Washington Public Power Supply System

Subject: **NUCLEAR PROJECT 3
CHANGES TO THE QUALITY ASSURANCE
PROGRAM DESCRIPTION**

Since the initiation and issuance of Amendment 5 to the FSAR, additional Supply System organizational changes have been made. These changes are detailed in Attachment 2 which presents a mark-up of FSAR Chapter 17 to show the changes which will be published in a future amendment.

WNP-3
FSAR

WNP-3 PROGRAM DIRECTORATE

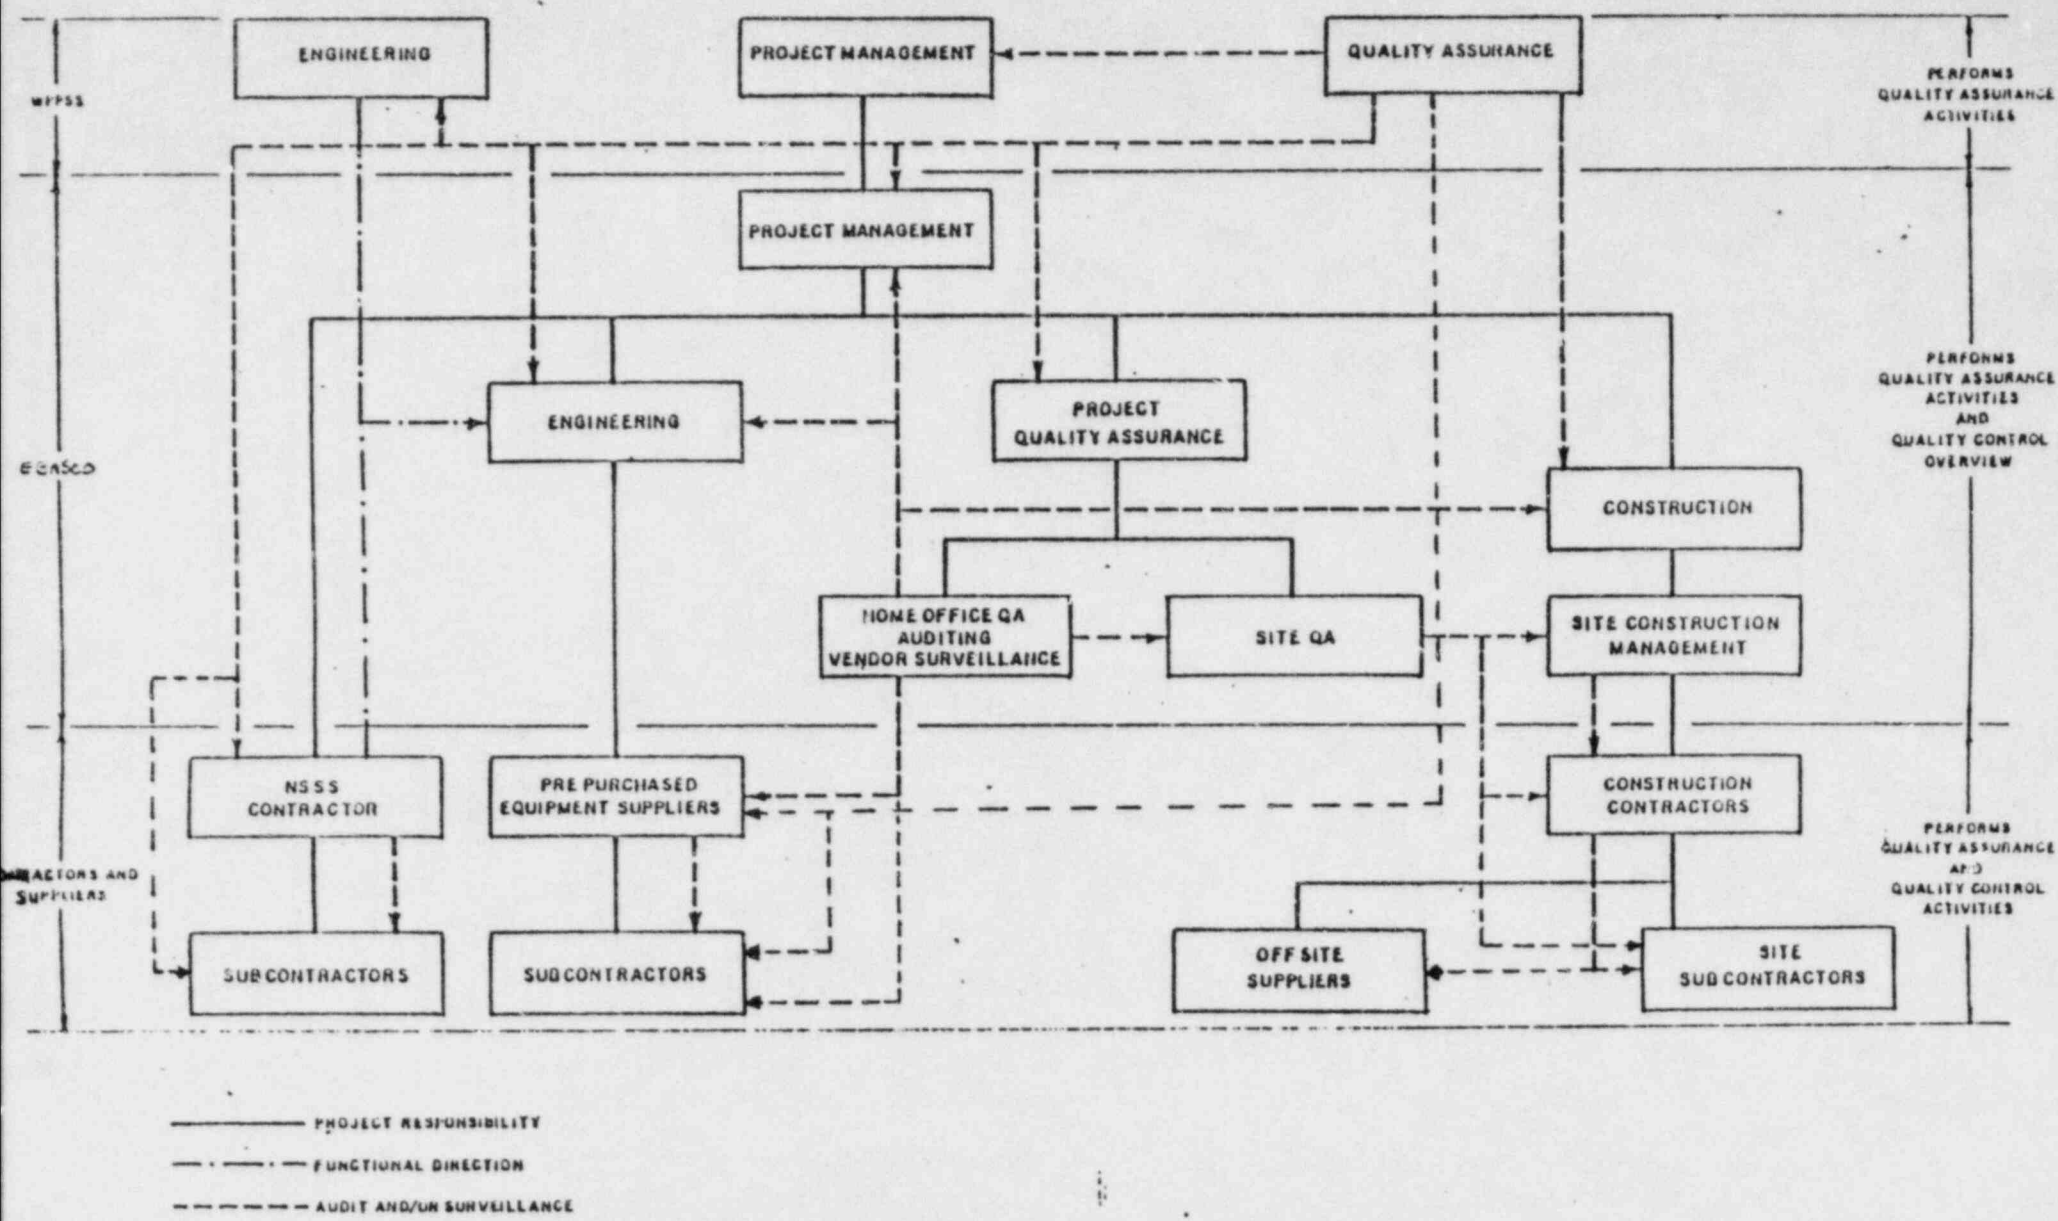
- ADDING THIS FIGURE -
